TOWN OF NEWBURGH PLANNING BOARD TECHNICAL REVIEW COMMENTS

PROJECT: HADID CLEARING & GRADING APPLICATION-34 SUSAN DR.

PROJECT NO.: 21-10

REVIEW DATE: 30 APRIL 2021 MEETING DATE: 6 MAY 2021

MONTGOMERY, NY 12549 Ph: (845) 457-7727 WWW.EP-PC.COM SITE PLAN HADID 34 SUSAN DRIVE TOWN OF NEWBURGH ORANGE COUNTY, NEW YORK 1" = 20' 0 - 01/06/21 46-5-21

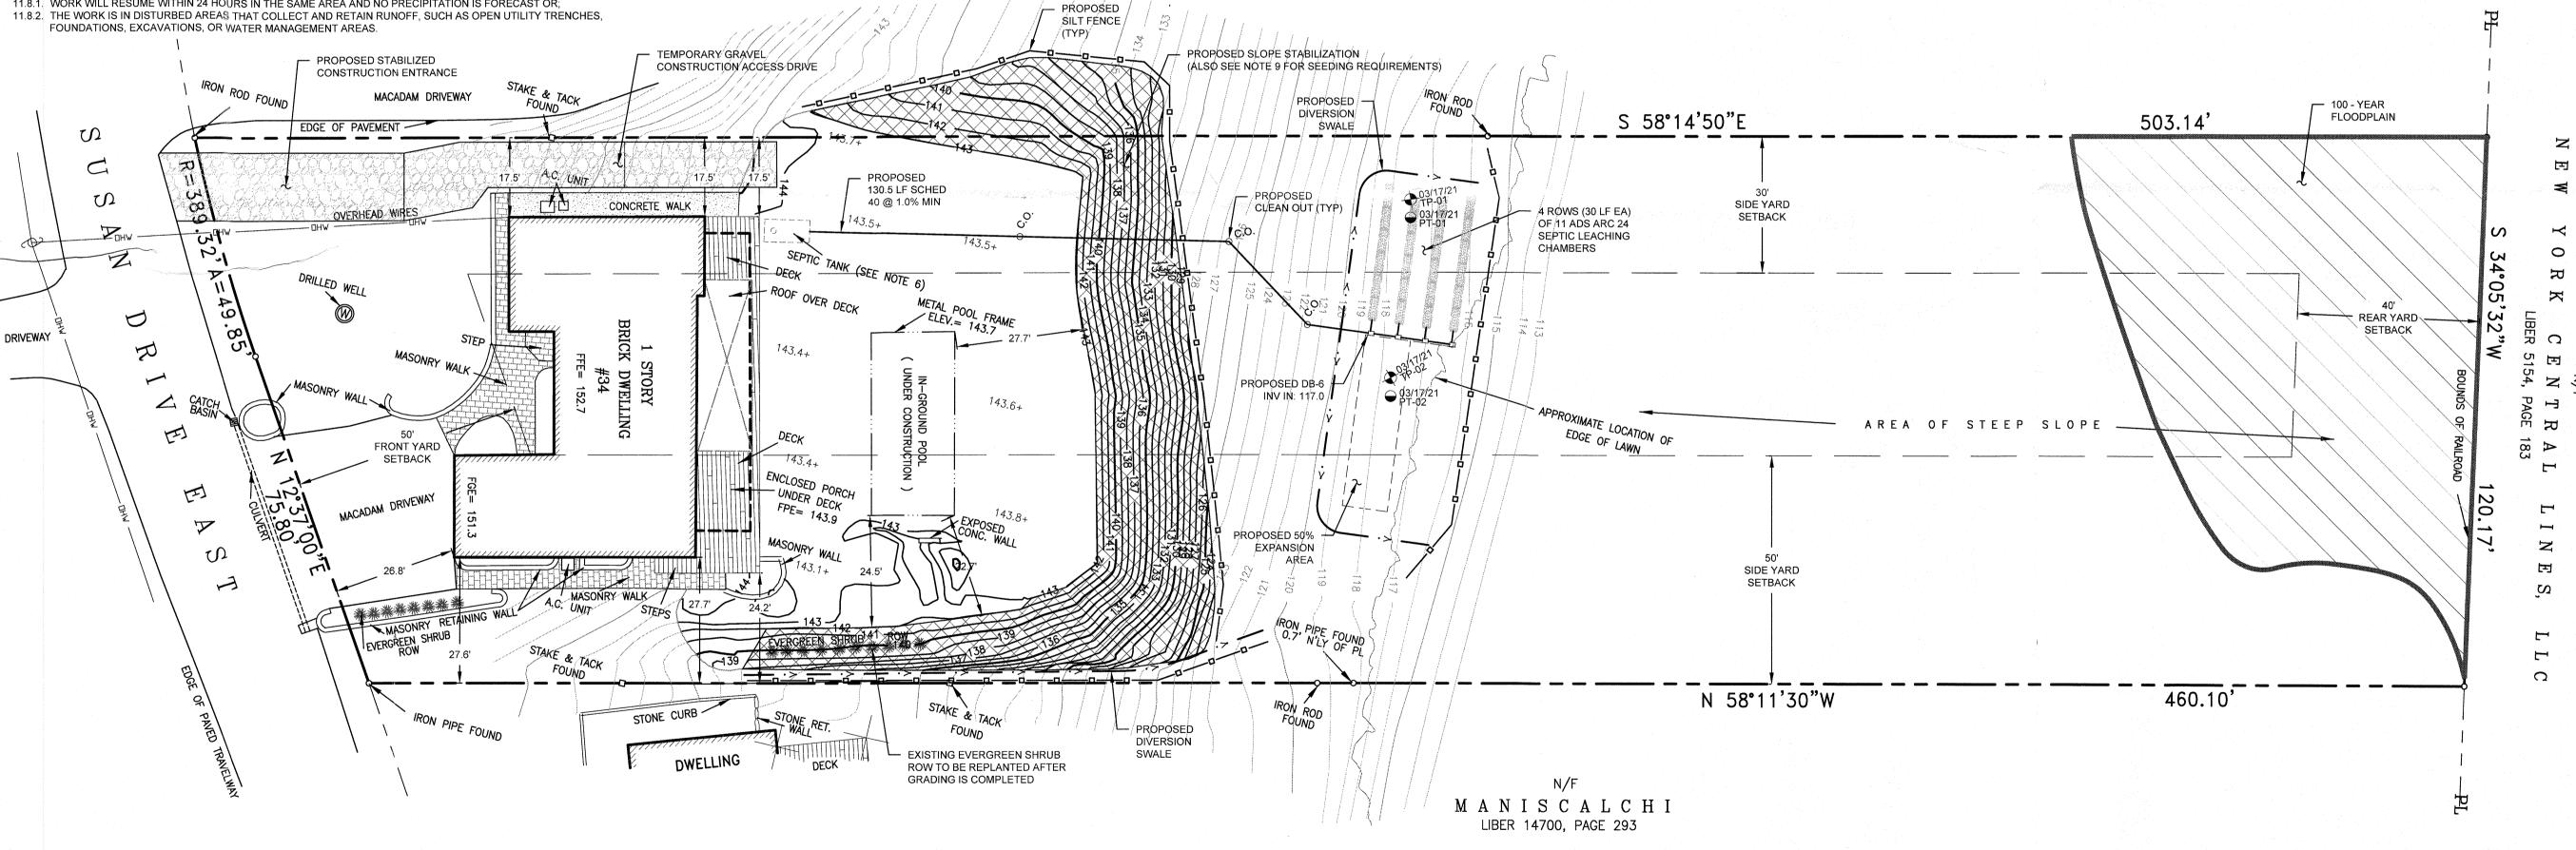
- **2.** It is unclear if the subsurface sanitary sewer disposal system has been constructed. Has leech field been constructed or is this a proposed leech field as indicated on the plans.

- **4.** The grading identifies an encroachment on the northern property line onto Lands now or formerly Schuyler. Grading appears to significantly impact the view from the property to the south.

- **6.** The slope identified to the rear of the property is approximately a one on one slope. I the fill is allowed to remain long term stability of that slope should be evaluated with a report prepared by a Geotechnical Design Professional. Similar comments to slopes on neighboring properties. The slope to the southern part of the property should also be addressed. It is requested the Applicants representative submit photographs of the fill material to evaluate impacts to adjoining properties.

- **7.** The plans should address access for construction of the subsurface sanitary sewer disposal system.
- **8.** The Applicants are requested to confirm that the structure is a three bedroom residence based on the septic design schedule.
- 9. The volume of fill placed on the site should be identified.
- **10.** A review of the google earth mapping identifies significant volume of fill having been placed prior to this application.
- **11.** The proposed and/or existing grading appears to have substantially exceeded the quantity of fill which would require a Clearing & Grading Permit. Section 183-8 E(3) "filling which exceeds a total of 3,000 cubic yards of material within any one parcel or any one subdivision excluding proposed public roads". This section requires Planning Board approval as well as a Public Hearing be held for the clearing & grading.
